September 18, 2002

HSA-10/B49C

In your July 25 letter to Mr. Richard Powers of my staff, you requested formal acceptance of a revised plastic guardrail offset block named RE-BLOCK:IV and provided a copy of a Texas Transportation Institute report dated July 19, 2002, and entitled "Pendulum Testing and Evaluation of the Central Fabricator's Guardrail Blockout."

4" X 8" X 14" RE-BLOCK - ADJUSTABLE W-BEAM

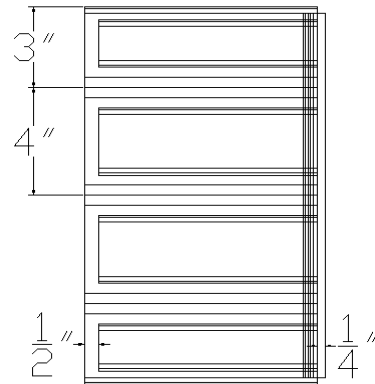
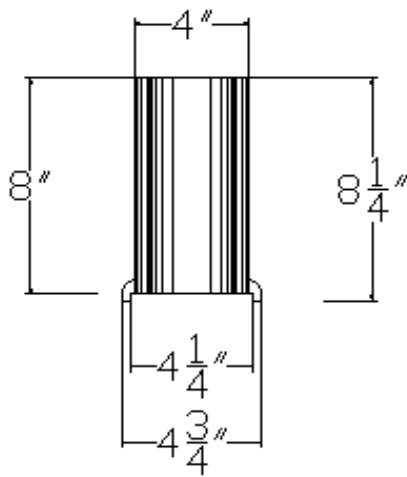
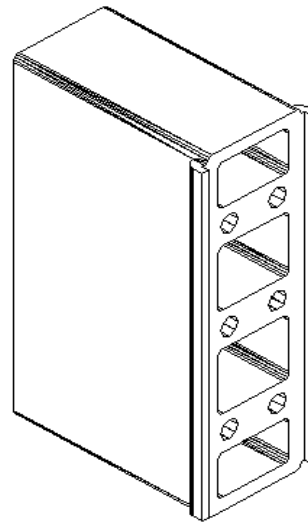
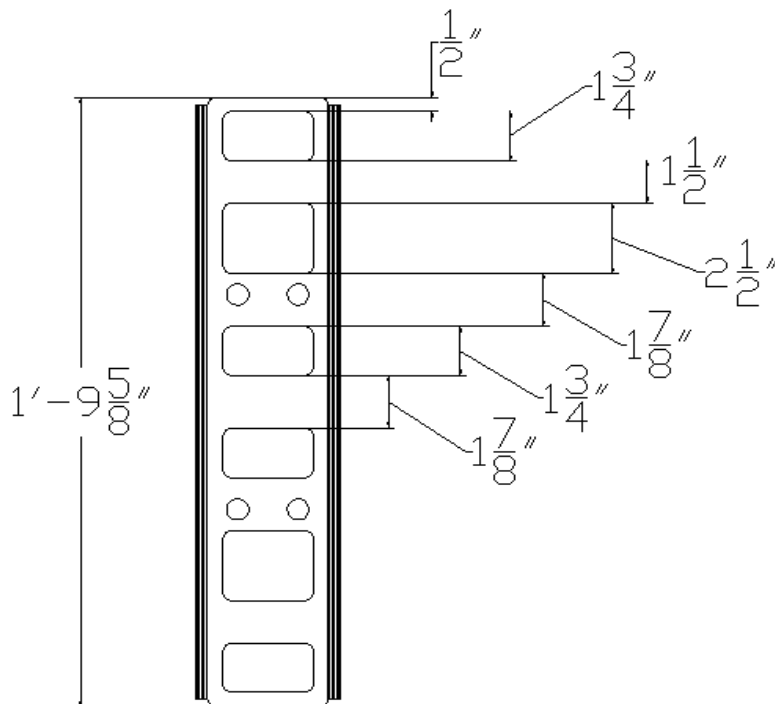
The RE-BLOCK:IV, as shown in the enclosure, is a hollow 4 inch x 8 inch block with three horizontal stabilizer bars and a depth of 14 inches for use with W-beam and 21-5/8 inches for use with Thrie-beam. Its material composition is similar to the original RE-BLOCK, using an average blend of 50 per cent HDPE and 50 per cent LDPE. Additionally, successful pendulum tests were conducted on a block made with 100 per cent HDPE and one made with 80 per cent HDPE and 20 per cent cross-linked HDPE/PP. All of these formulations include approximately 1 per cent carbon black to reduce the effects of UV degradation.

Based on staff review of the information you provided, the appropriate-sized RE-BLOCK:IV may be used with wood or steel strong-post W-beam and Thrie-beam guardrail systems on the National Highway System (NHS) when such use is acceptable to the contracting agency.
